**PROPOSED 'PLACE OF RECREATION, SPORTS OR CULTURE
(PUBLIC RIDING SCHOOL WITH ANCILLARY FACILITIES)' AT
THE RESTORED LANDFILL SITE (TKOL II/III)
IN TKO AREA 105, TSEUNG KWAN O (GLA TSK-500)
(TPB No. A/TKO/134)**

RESPONSES-TO-COMMENTS TABLE

PROPOSED PLACE OF RECREATION, SPORTS OR CULTURE (PUBLIC RIDING SCHOOL) WITH ANCILLARY FACILITIES AT GOVERNMENT LAND IN D.D. 233, THE RESTORED LANDFILL SITE (TKOL II/III) IN TKO AREA 105, TSEUNG KWAN O (GLA TSK-500 (PART)) [TPB REF: A/TKO/134]

Drawing Title							
YEAR 2033 REFERENCE TRAFFIC FLOWS (WITHOUT PROPOSED PRS DEVELOPMENT) - WEEKDAY							
Designed	CSY	Checked	GPH	Scale	NTS	Date	JUL 2025
Drawing No.	4.2			Rev.	C

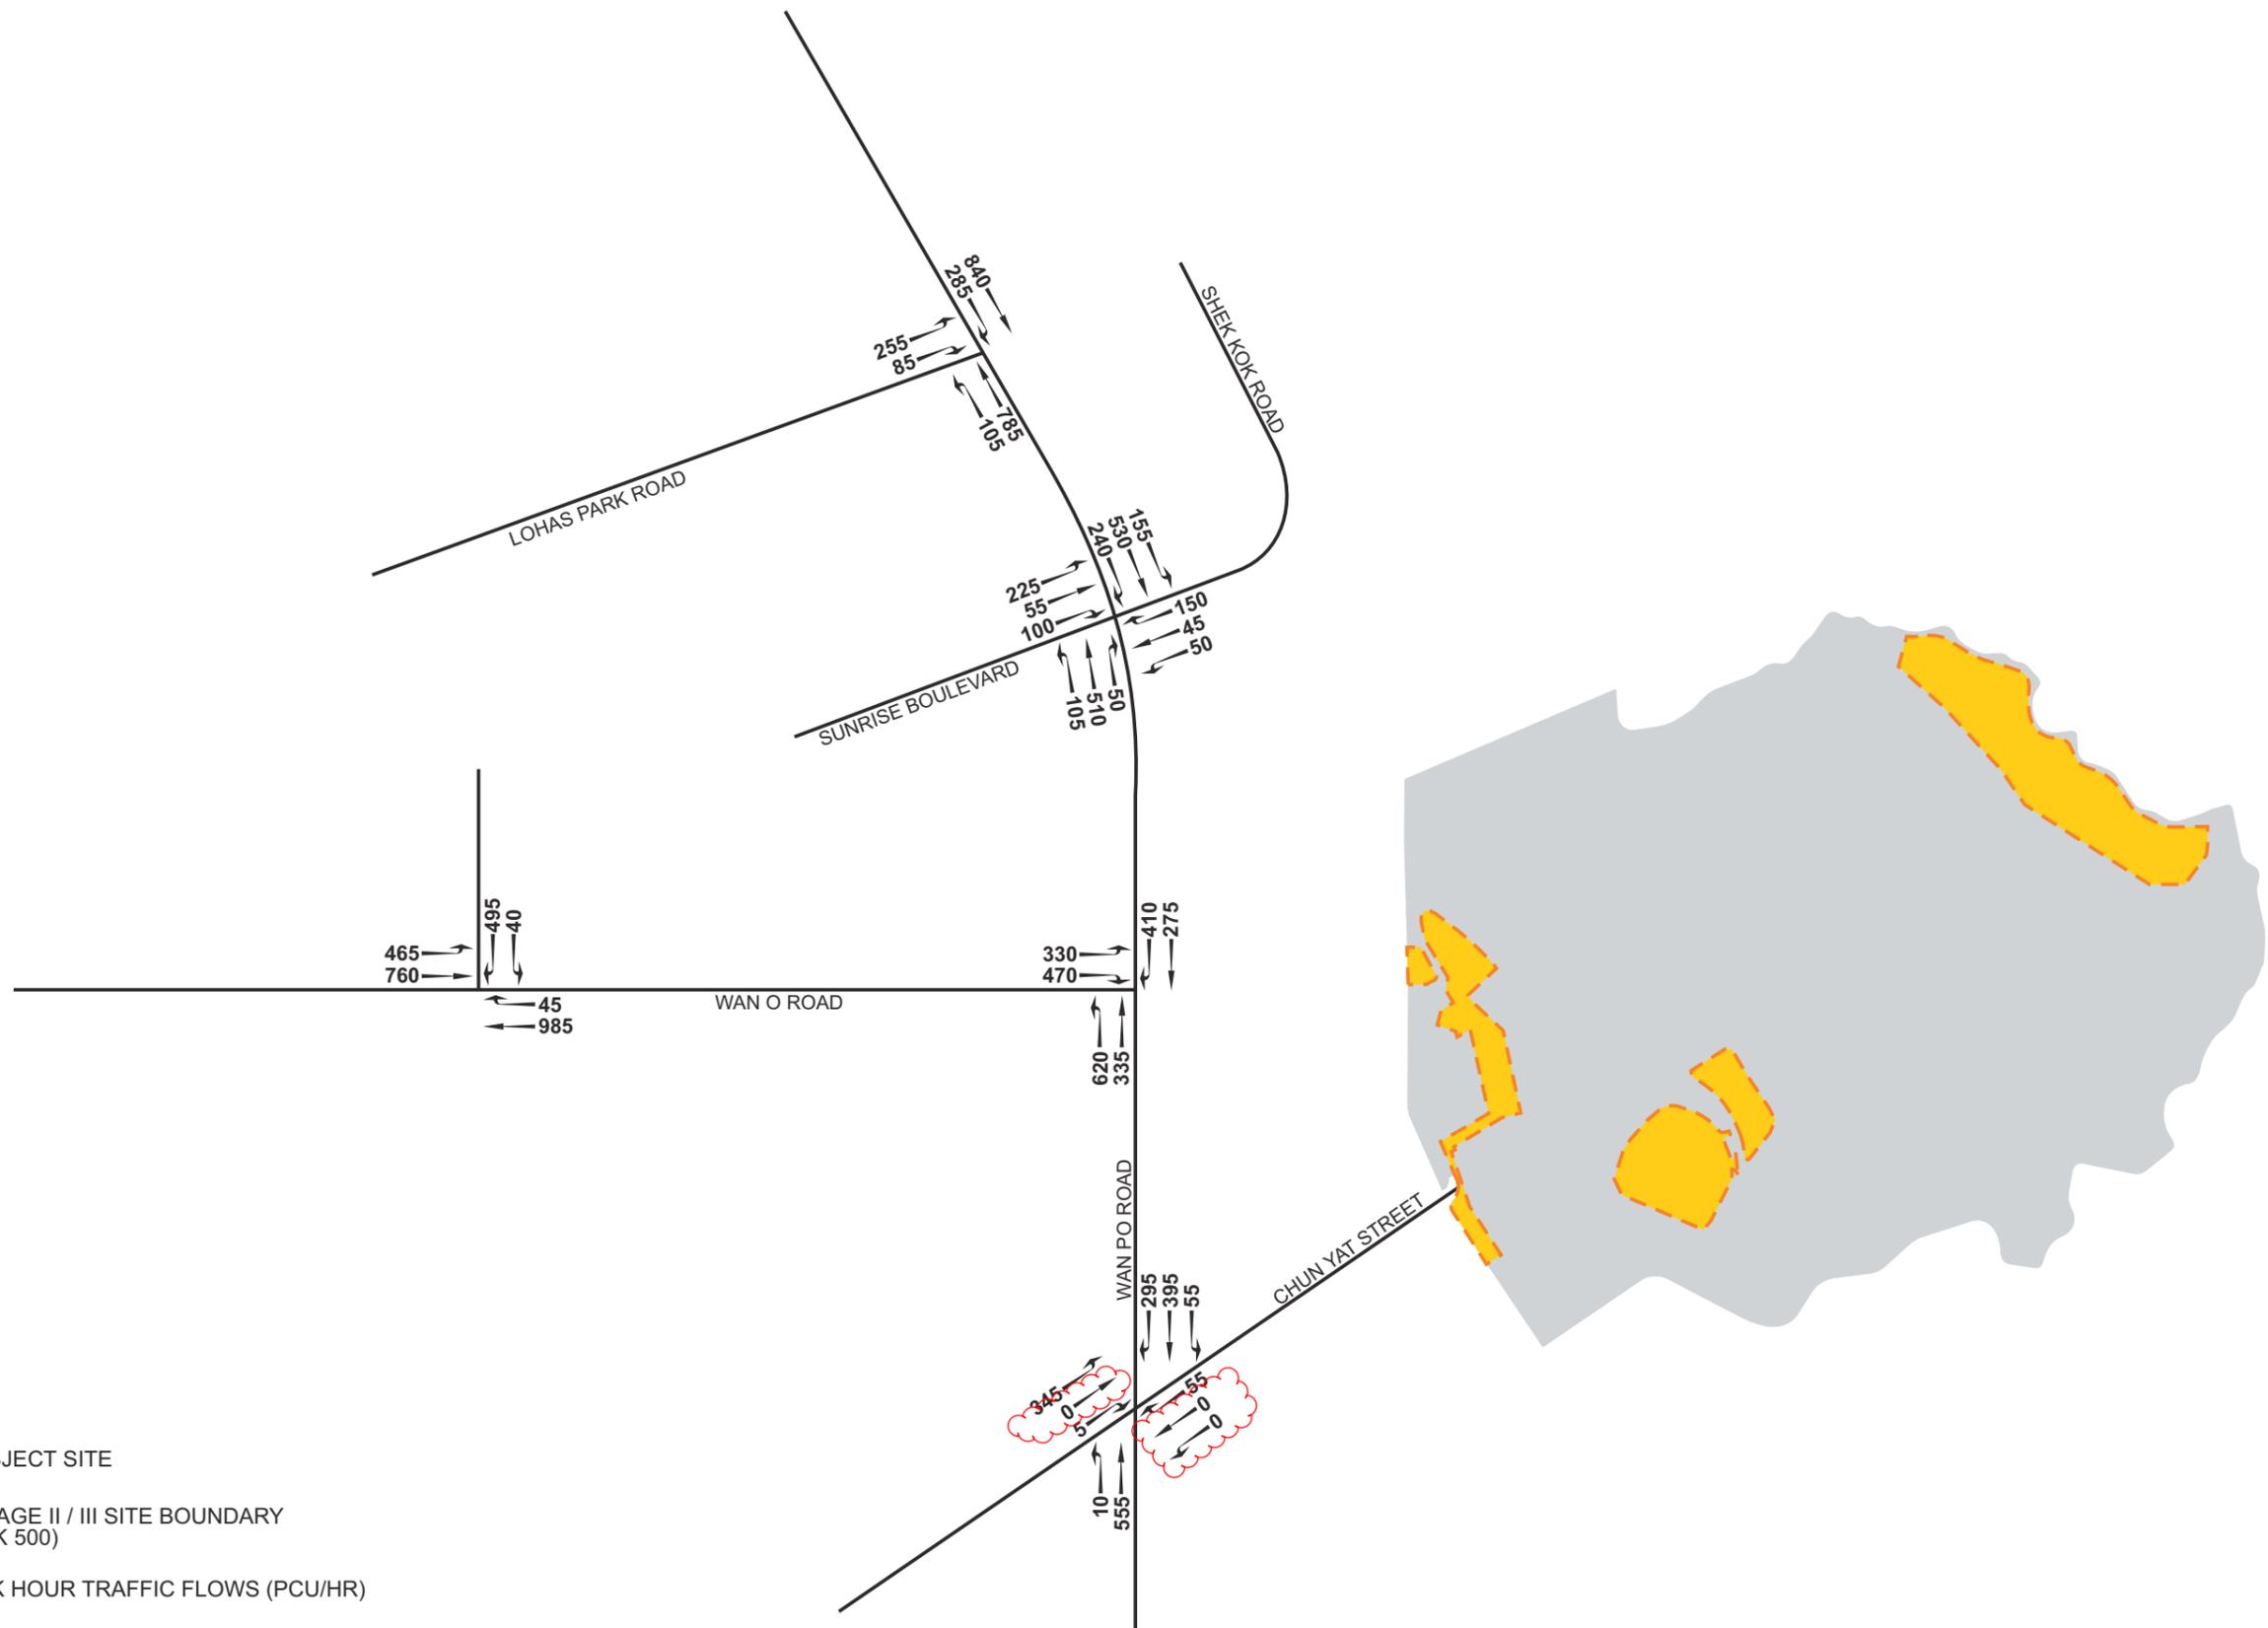
j.	Drawings 4.1 – 4.7 – Please update the traffic flows for Chun Yat Street WB.	Noted and the Drawings 4.1 to Drawings 4.7 have been revised. Please refer to the replacement pages of the TIA (Attachment 2 refers).																								
	<u>Comments from Transport Operations (NT) Division</u>
